Public Comments

Environmental Impact Analysis Process

FINAL ENVIRONMENTAL IMPACT STATEMENT
MX: MILESTONE II

4. TITLE (and Subtitle) MX: MILESTONE II-FINAL ENVIRONMENTAL IMPACT STATEMENT, VOL VI, PUBLIC COMMENTS	5. TYPE OF REPORT & PERIODICITY FINAL ENVIRONMENTAL IMPACT STATEMENT 1979

Figure 1-11. South Platte Plains Basing Mode Comparison Area.

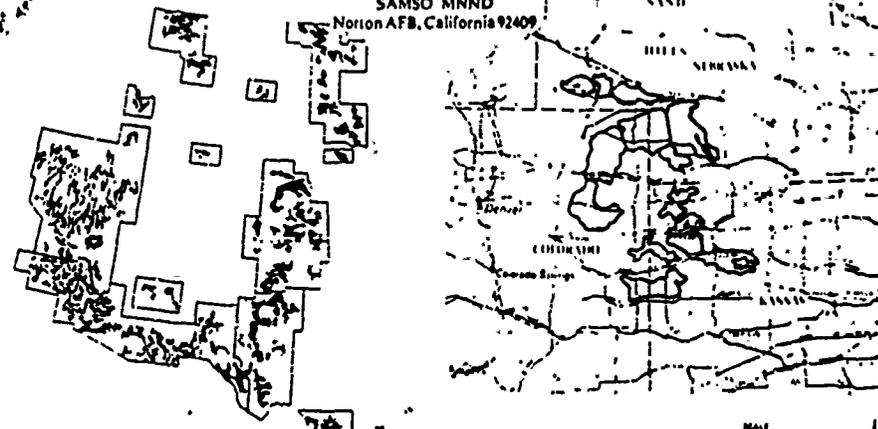
Following is a list of towns compiled from looking at a road map and comparing it to Figure 1-11. (IV-62) All are generally in the area under consideration for the MX. We would like to know more exactly 1) which towns are inside the BMCA; 2) which towns are inside the BMCA but not listed here; and 3) which ones are outside.

Is the map from Draft Environment Impact Statement
MX Milestone 11, Figure 1-11 going to cover this
area, or could it be even more? I need to know
more, as I'm in the area mentioned. How soon
would this project begin also? Will this require
the farmers to move off the land and etc?
